August 4, 2021

RE: Cape View Way Development

CAPE VIEW WAY
PERMITTING PLANS
BOURNE, MASSACHUSETTS

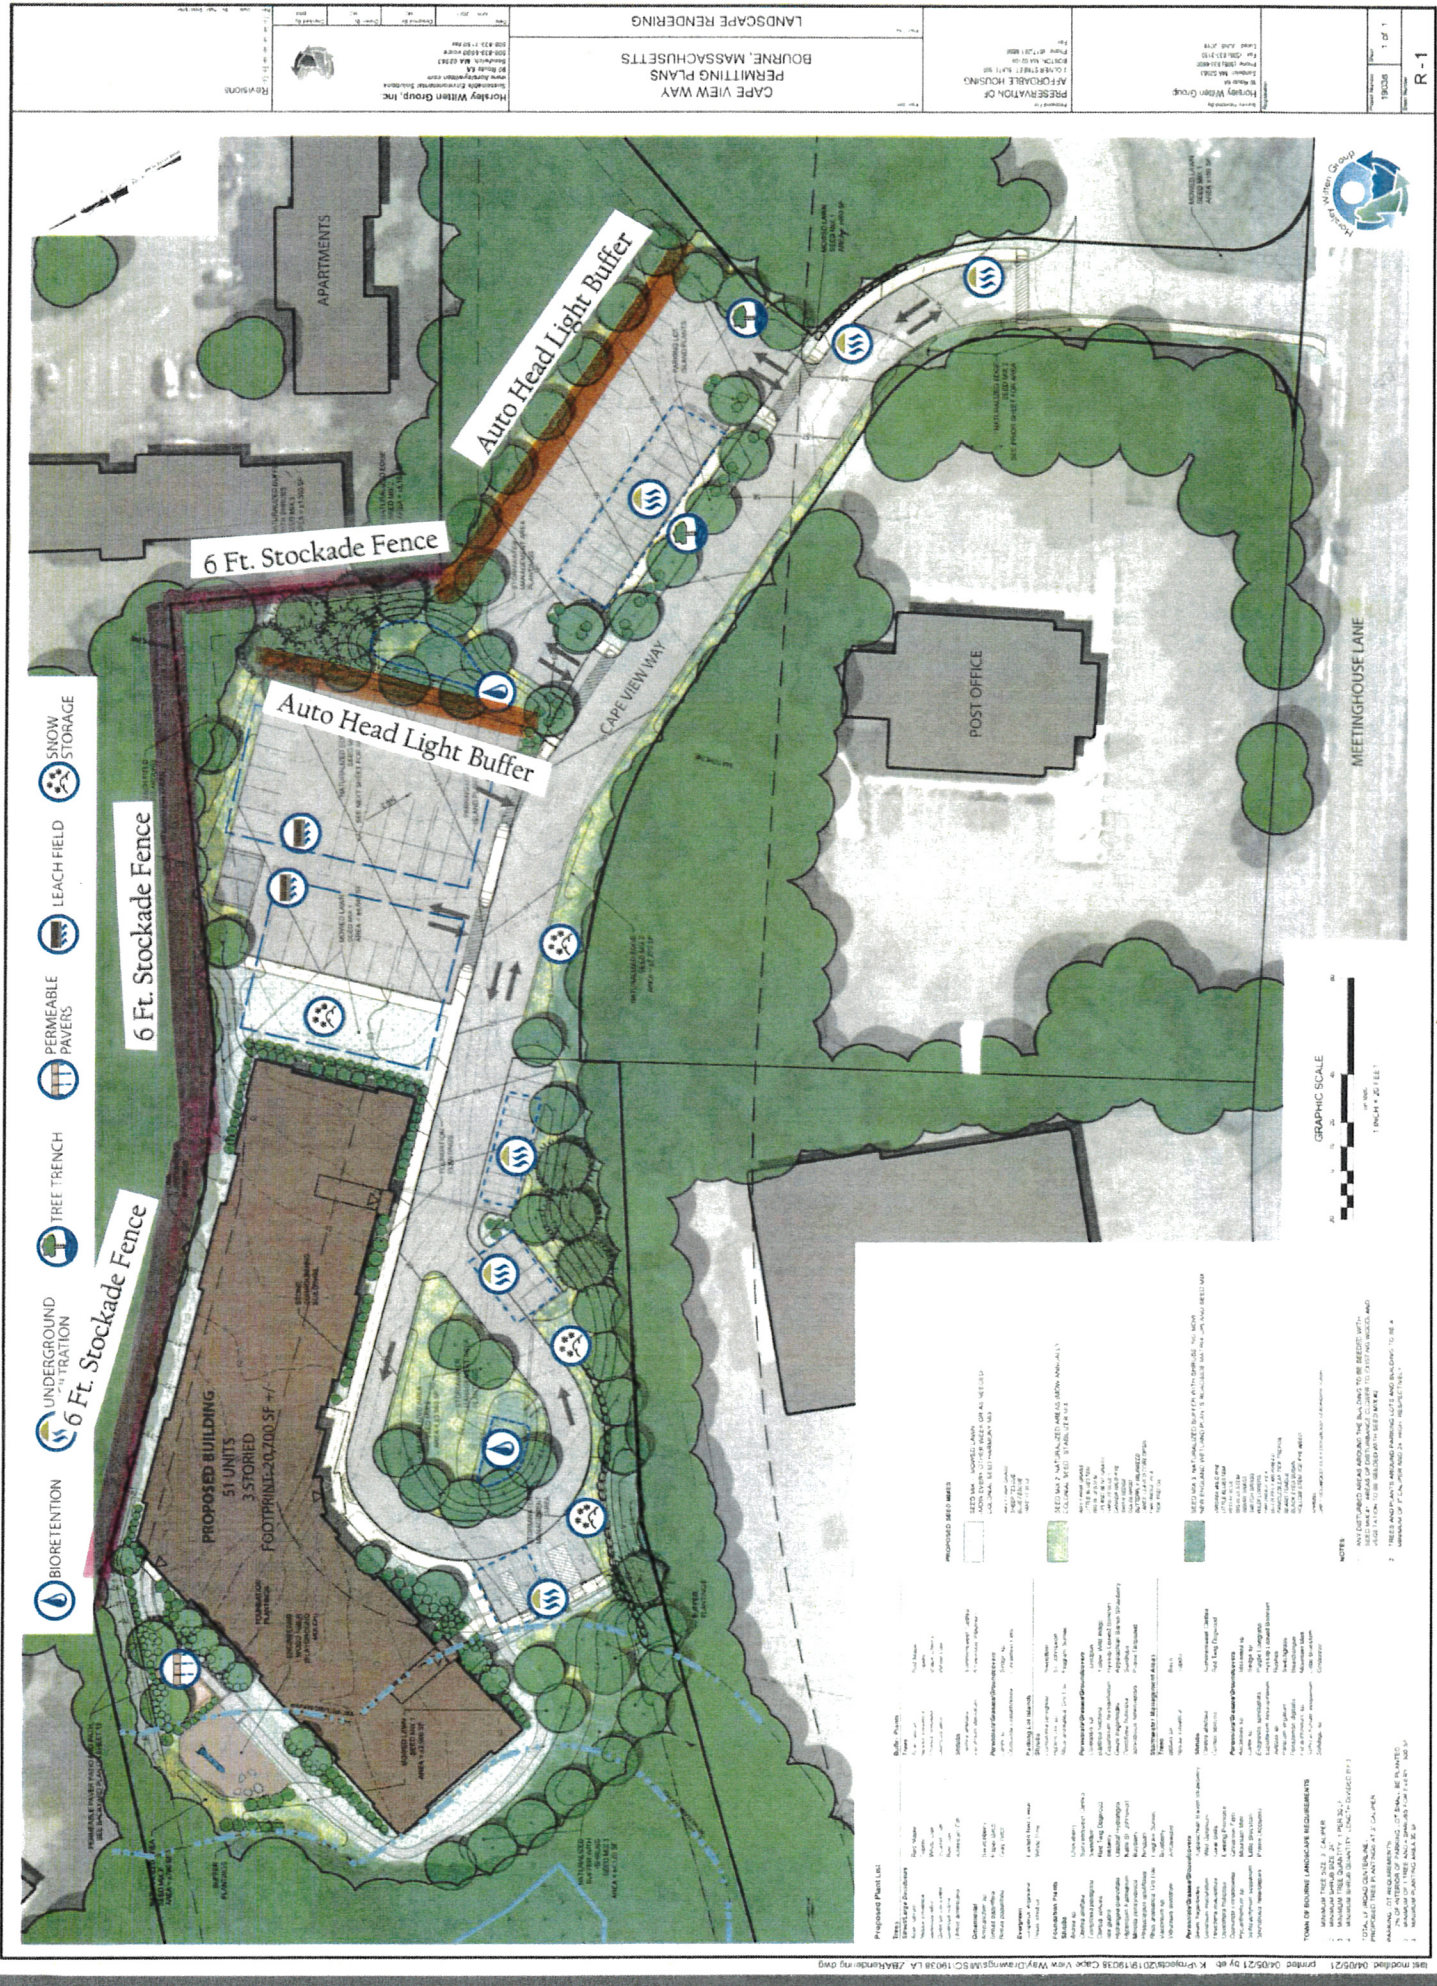
At the July 7, 2021 hearing we agreed to submit a sketch plan for the August 4th ZBA meeting that would show the screening or fencing that we are requesting. Attached is the sketch plan superimposed on the Applicant's most recent landscape plan. The attached plan illustrates the location for a requested stockade fence and the natural screening to blunt headlights and noise that will emanate from the parking lots. We feel that any conditions as to vegetated screening should specify the screening material or plants and require the Applicant to maintain such screening. The Applicant should also be required to maintain the fence in good condition.

Insofar as the green area shown on the upper right corner or Northeasterly corner of the Applicant's landscape plan, there is a question as to the extent of the preservation of natural material. The Applicant has represented that this area will be used for a leaching field. If this is the case, it will mean that the ground must be cleared in order to accommodate such a leaching field. Therefore, the Applicant needs to specify what natural material will be retained and what material will be planted in the area designated for a leaching field and that directly abuts along my client's property line.

6 Ft. Stockade Fence

Auto Head Light Buffer
